## Annex I-Alterations of the premises

### Alteration 1- New Head of Unit office - 14<sup>th</sup> floor

### 14th floor - revision

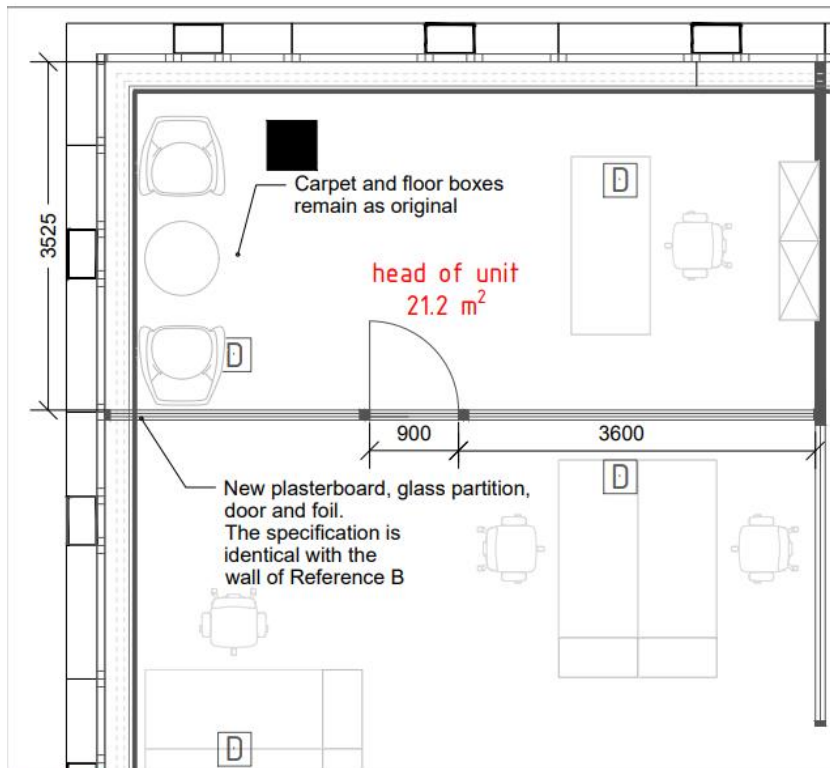
Location and concept layout of the proposed office (Detail A) with a brief description and an existing office on the same floor (Reference B) with a similar layout and specifications.

Alteration 2 - Electric blinds

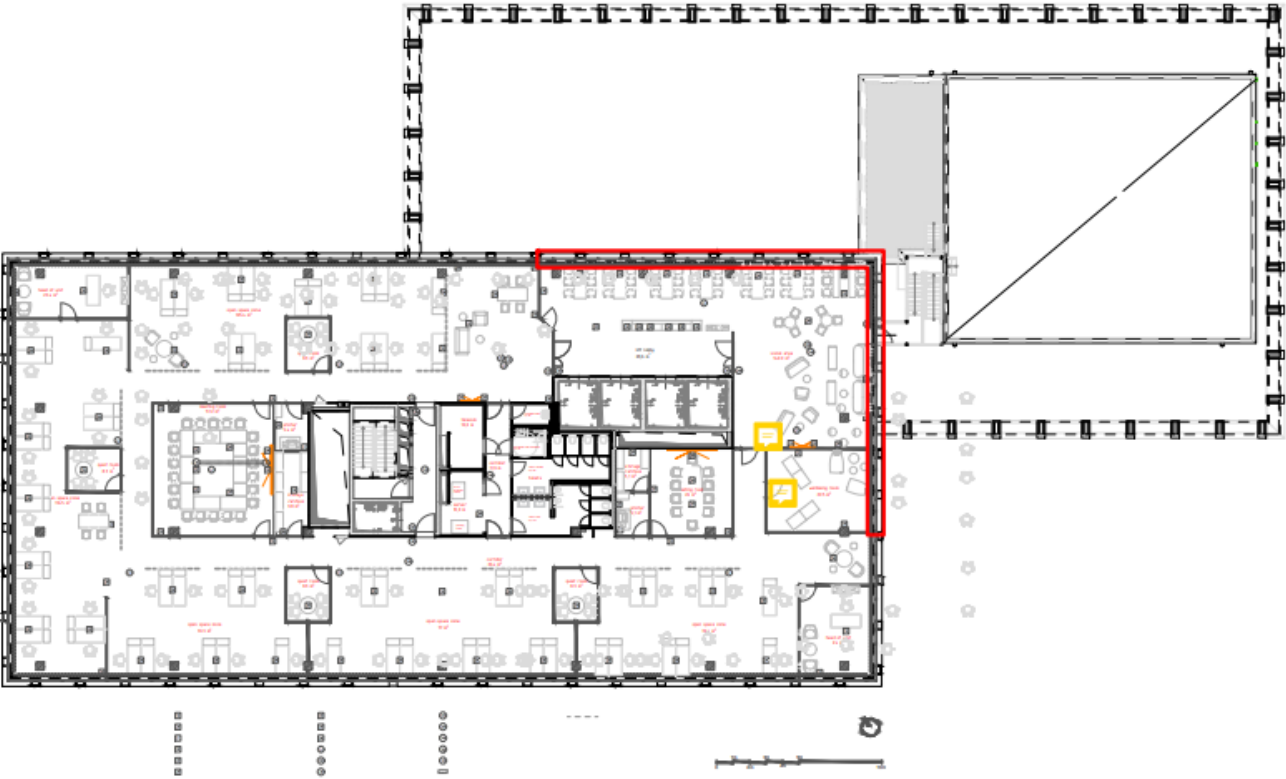
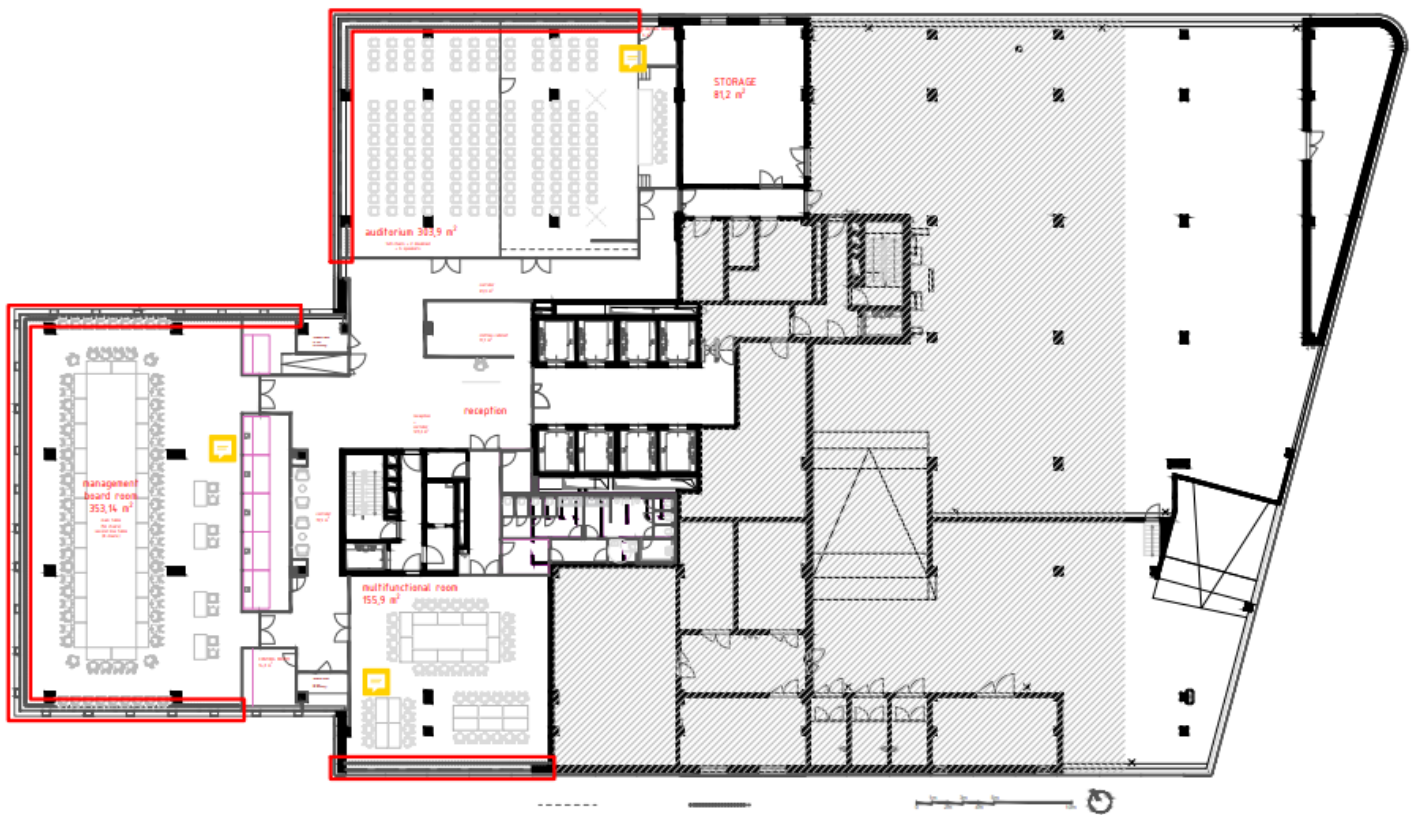
Locations of the proposed electrical steering of existing window blinds marked by a red frame.

<p>on the 3rd, 13th and 14th floors. On the 3rd floor – for all blinds in the Management Board Room, Auditorium and Multifunctional room. On the 13th floor- for all blinds in the Social area and the Relax room and on the 14th floor for all blinds in the ED room and Mont Blanc meeting room. This system will enable a comfortable and fast handling of the blinds. The steering will be handled with a wall or desk mounted switches steering multiple modules separately. The installation will require attaching motors to the blind ropes, mounting switches and placing electrical cabling. ELA will procure the material and works of the elctrical steering.</p>			
Acoustic improvement of a wall	14	04/12/2024	04/12/2024	<p>This improvement results in lowering of wall resonance between the Mont Blanc meeting room and the Executive Director’s office. The issue is , that during a meeting the noise emitted by the voices in the room is transmitted to the director’s office and causes disturbance. The same happens the other direction during the meetings in the Director’s office. The wall is a standard 100 mm plasterboard wall with the surface of 21 m<sup>2</sup>. On</p>	Not needed	Not needed	Yes, therefore a communication to the Building manager

### Alteration 3- Acoustic improvement of a wall-14th floor

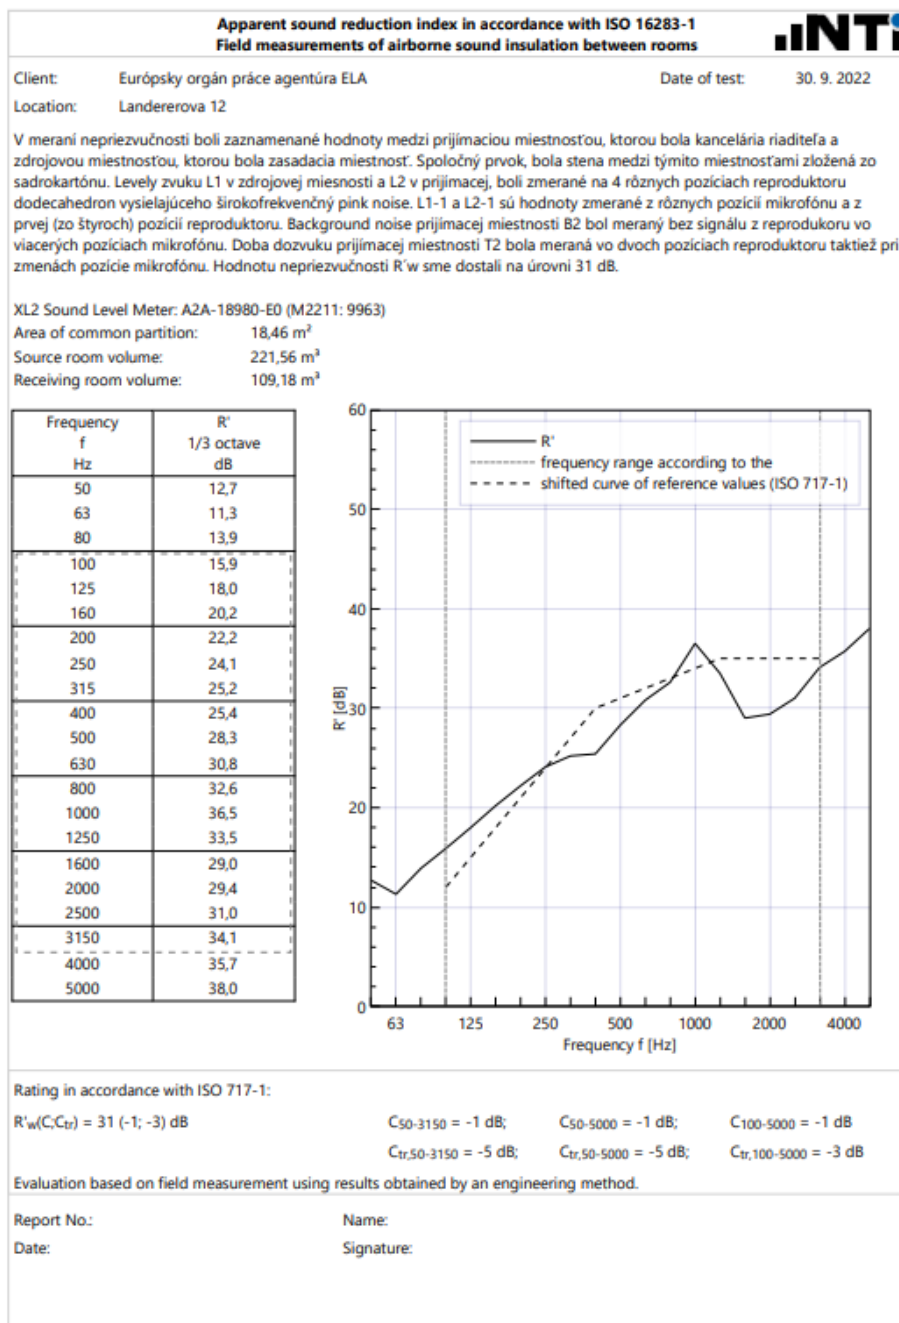
Report with the results of sound insulation measurements between ED office room and the adjacent meeting room.

Location of the proposed acoustic improvement marked by a red frame.

Proposed solution with material and works description.

Názov	Typ konštrukcie	Útlm Rw celej konštrukcie do* (dB)	Hrúbka profilu	Hrúbka od (cm)
<b>INDIVIDUAL</b>	bezkontaktná	<b>55-60</b>	5 cm	11,1 cm
sadrokartón-Silio 16-Topsilent Adhesive-Silent Foam 40mm-Silio 16-sadrokartón

<p>30.09.2022 ELA contracted a professional test measuring the acoustic situation in both rooms. The results of the tests showed insufficient acoustic conditions. The advice is to improve the acoustic conditions by installing a special acoustic panels onto the abovementioned wall. This measure will lower the wall resonance to an acceptable acoustic level and improve the working comfort in both rooms. ELA will procure the material and works of the acoustic wall.</p>			
--	--	--	--	---	--	--	--
